APPLICATION NO: 17/02460/FUL		OFFICER: Miss Michelle Payne	
DATE REGISTERED: 19th December 2017		DATE OF EXPIRY: 20th March 2018 (extended by agreement with the applicant until 27th April 2018)	
WARD: St Marks		PARISH: n/a	
APPLICANT:	New Dawn Homes Ltd		
AGENT:	New Dawn Homes Ltd		
LOCATION:	Playing Field Adj 10 Stone Crescent, Cheltenham		
PROPOSAL:	Erection of 13no. dwellings with associated road and sewers

Update to Officer Report

Figure 1 - LiDAR and Flow Accumulation

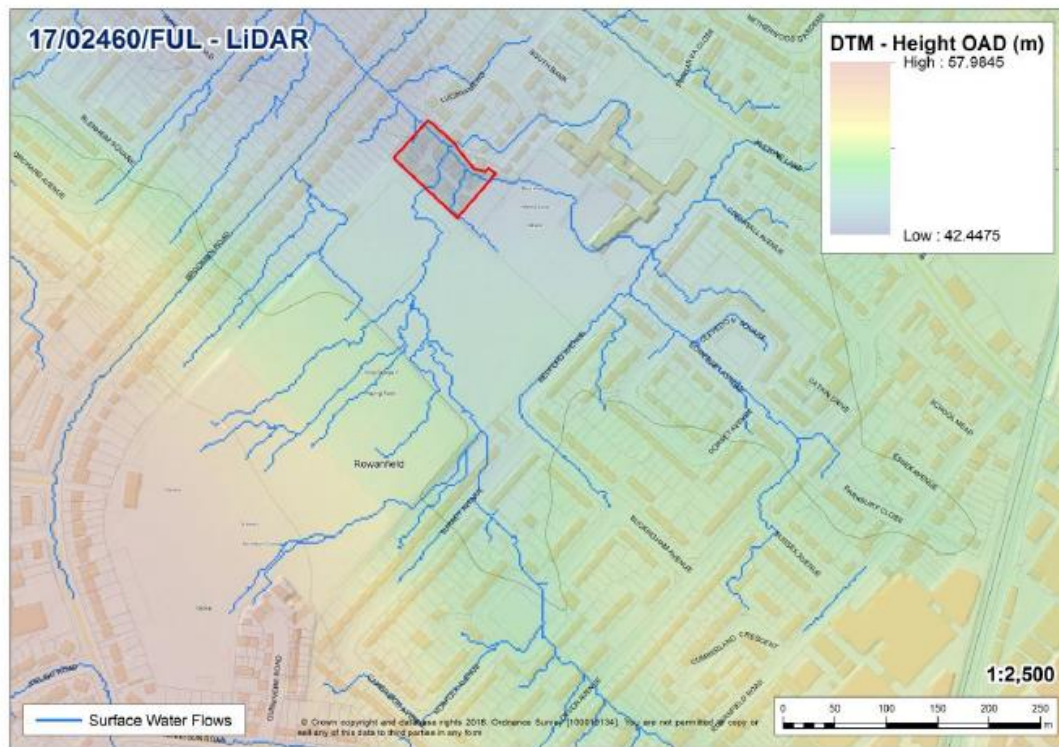
Although it has been stated by the applicant that the soil from the adjacent fields lends itself to allow for infiltration, any surface during rainfall events (e.g. 1% or 3.33% Annual Exceedance Percentage (AEP)) will almost certainly generate runoff. The characteristics of the field will determine rate and quantity of runoff that will be generated. In addition to this, LiDAR clearly shows the development site to be the lowest point of the greater greenspace where surface flows will naturally drain to. A flow accumulation assessment carried out by the LLFA on the LiDAR confirms these flows do drain through the development site, see Figure 1.

As recommended by BS8533:2017 (Assessing and Managing flood risk in development. Code of practice), surface water flows that could enter the site from elsewhere should be realised and considered to ensure surface water does not pose a flood risk to development. The LLFA acknowledges the applicant has stated a cut-off drain could be installed;

however its hydraulic performance and ability to manage the surface water flows has not been explored nor stated (i.e the adequacy of the cut-off drain to capture the runoff that would drain to the site from the adjacent fields). Therefore, the FRA has not assessed the surface water flow from the adjacent fields sufficiently to convince the LLFA that these properties will not be at risk of flooding from surface water in accordance with the requirements of the NPPF. On this basis the LLFA does not support the principle of the development that is currently being presented.

Figure 2 – Environment Agency Surface Water Flood Maps

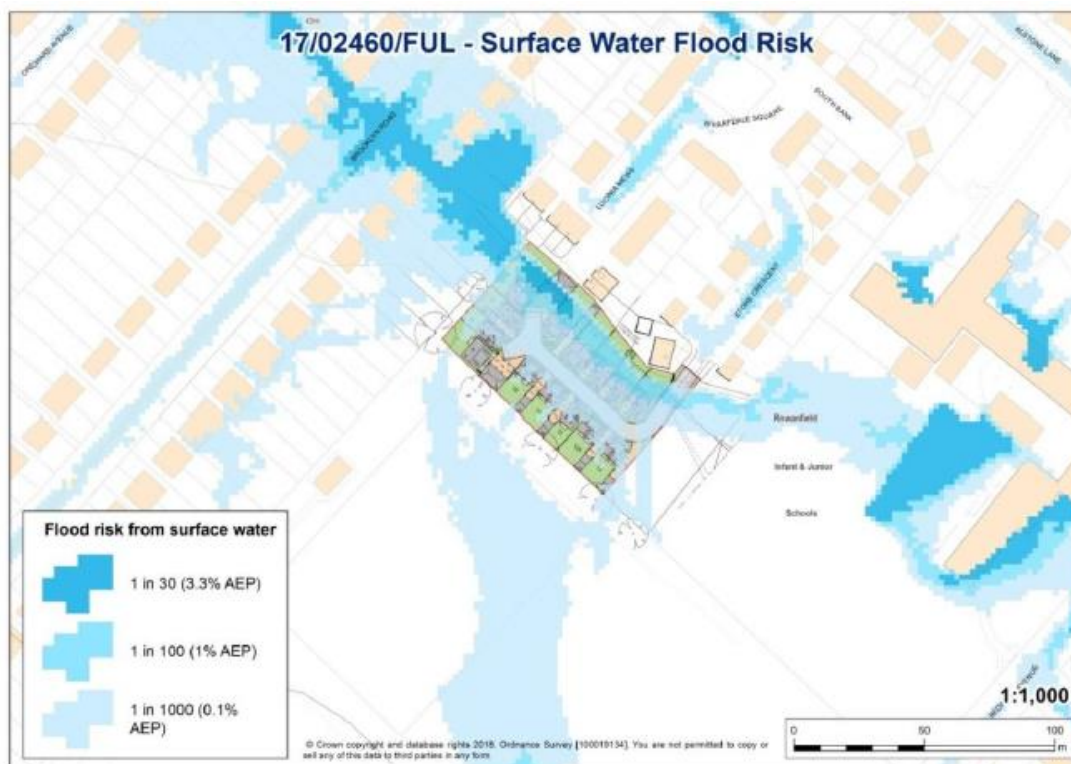
This is reflected in the Environment Agency's surface water flood risk mapping, see figure 2, which show surface water flows travelling directly through the proposed site, in particular during a 3.33% AEP event (also known as the 1 in 30 year event) and the 1% AEP event. Also of note, the site is predominately within the 0.1% AEP extent (i.e. 1 in 1000 year flood extent).
